Application for Licence

Licence Number	L5989/1991/12
Applicant	Water Corporation
File number	2010/003537-1
Premises	Northam Water Resource Recovery Facility Crown Reserve 25729 Legal description Lot 29316 on Deposited Plan 221054 Lot 500 and Lot 501 on Deposited Plan 76392 NORTHAM WA 6401 As defined by the premises map attached to the issued licence
Date of report	3 December 2024
Decision	Licence granted

Figure 6: Surface water monitoring locations within the Avon River

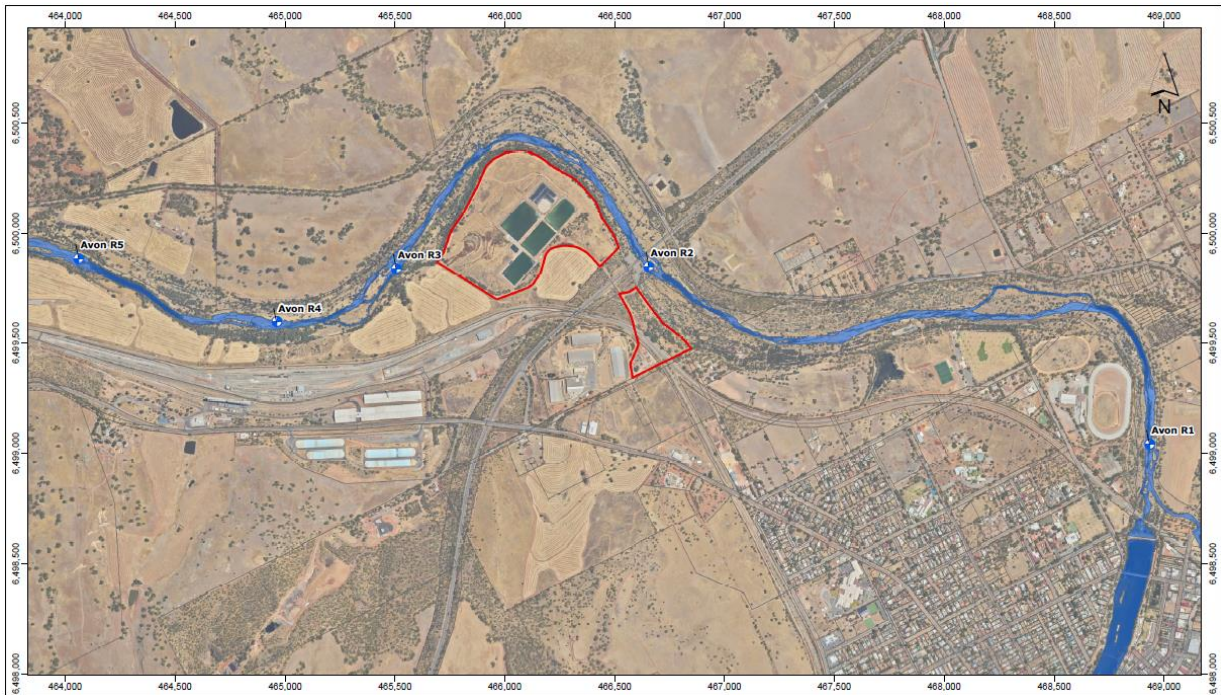
<p>Condition 15 Table 9 (Draft condition 18, Table 10)</p>	<p>Updated map provided, as requested by DWER, depicting the surface water monitoring point locations.</p>	<p>Figure 4 of the Licence and Figure 3 of the Decision Report updated with the map of the 5 surface water monitoring locations.</p> <p>For consistency, column 1 of Table 9 (draft Table 10) is amended to depict the correct monitoring point location names, as shown in the provided map.</p>
